Docket No. 50-321

EDWIN I. HATCH NUCLEAR PLANT UNIT NO. 1

AMENDMENT TO FACILITY OPERATING LICENSE

Amendment No. 69
License No. DPR-57

FIGURE 1.1-1
 CORE THERMAL POWER SAFETY LIMIT
 VERSUS CORE FLOW RATE

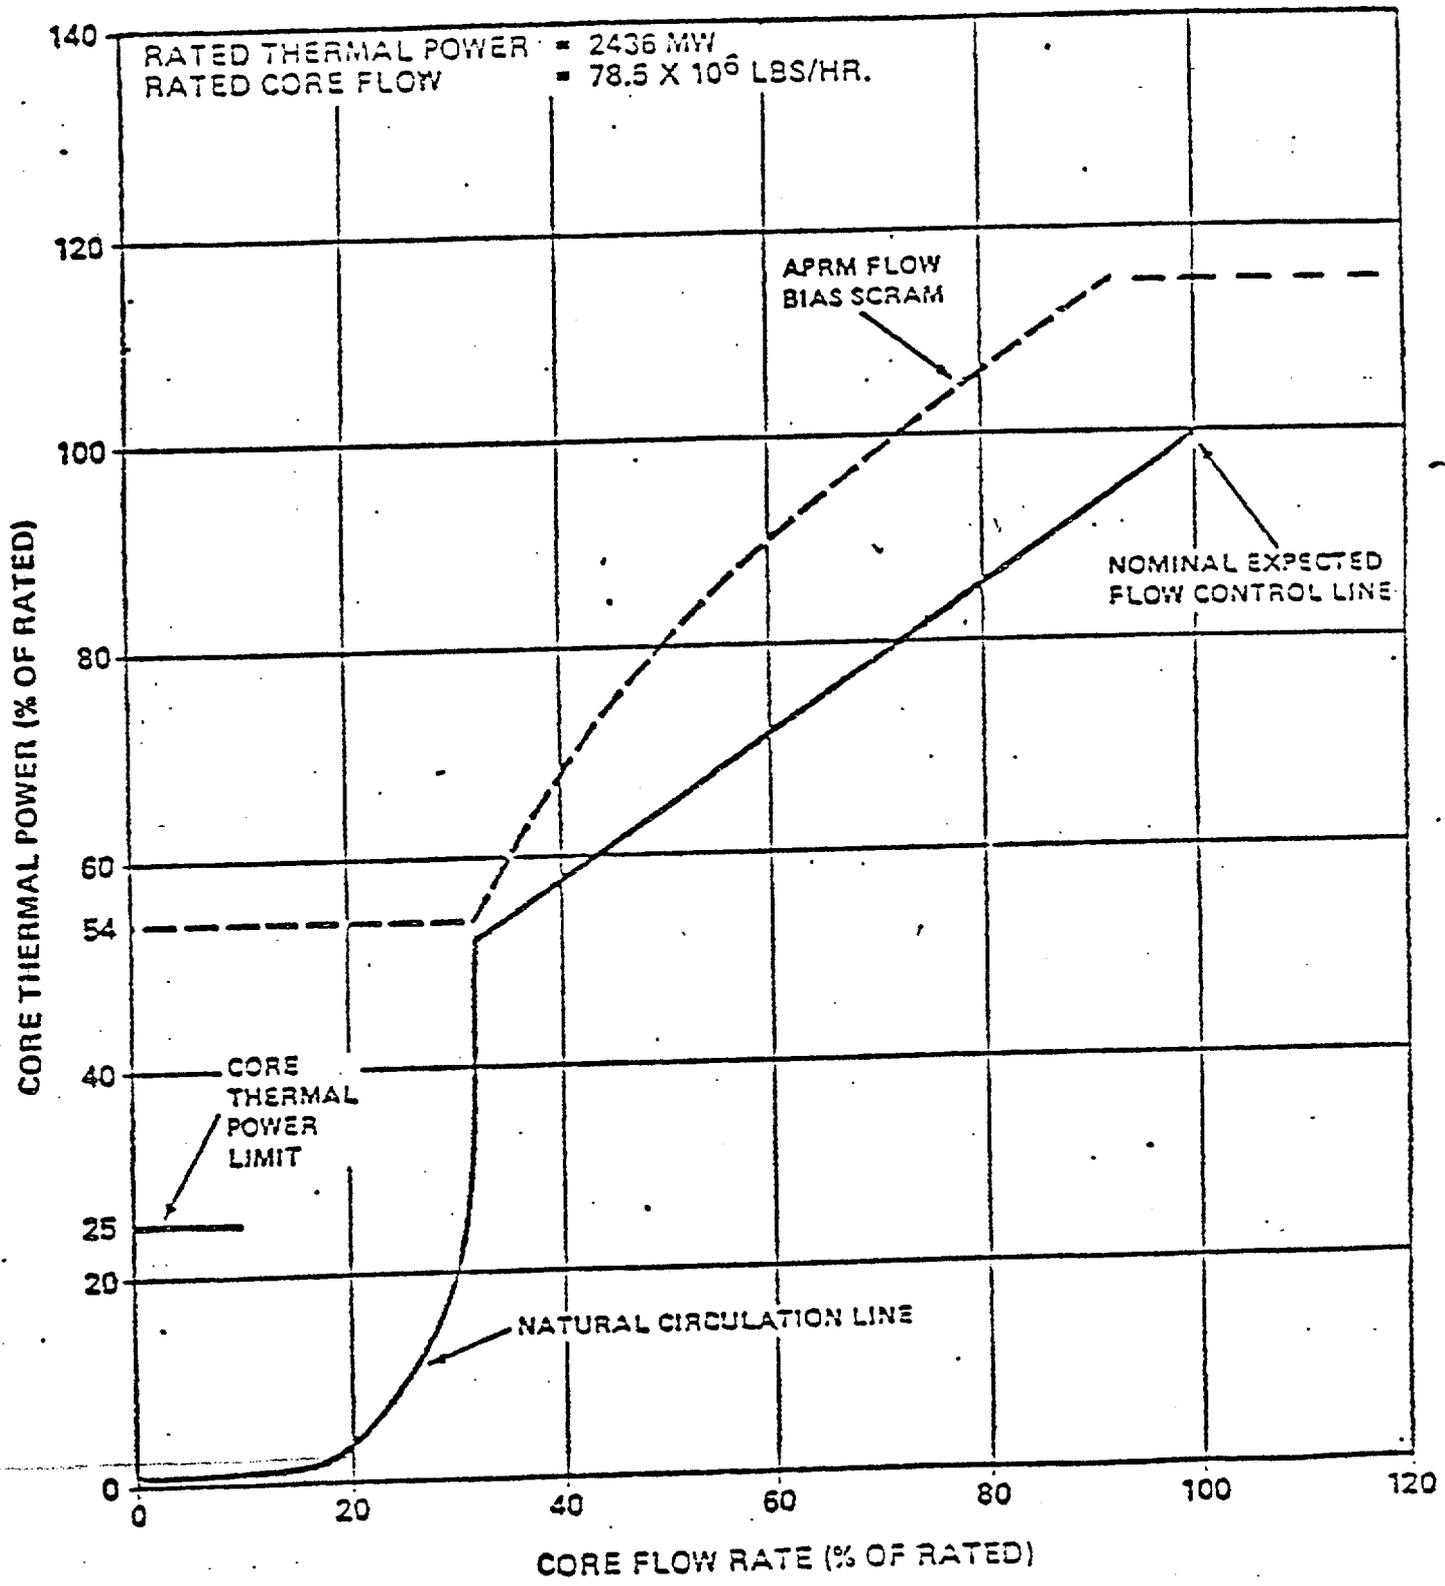
<u>REMOVE</u>		<u>INSERT</u>
	ix		ix
	1.1-1		1.1-1
	1.1-2		1.1-2
	1.1-12		1.1-12
	1.1-13		1.1-13
Fig.	1.1-1	Fig.	1.1-1
	1.2-3		1.2-3
	1.2-5		1.2-5
	3.1-4		3.1-4
	3.1-7		3.1-7
	3.1-11 *		3.1-11
	3.1-12		3.1-12
	3.2-27		3.2-27
	3.2-28 *		3.2-28
	3.2-29 *		3.2-29
	3.2-30		3.2-30
	3.6-20		3.6-20
	3.11-1		3.11-1
	3.11-2		3.11-2
	3.11-4		3.11-4
Fig.	3.11-2 (Sheet 1)		(deleted)
Fig.	3.11-2 (Sheet 2)		(deleted)
	5.0-1		5.0-1

The existence of a minimum critical power ratio (MCPR) less than 1.07 shall constitute violation of the fuel cladding integrity safety limit.
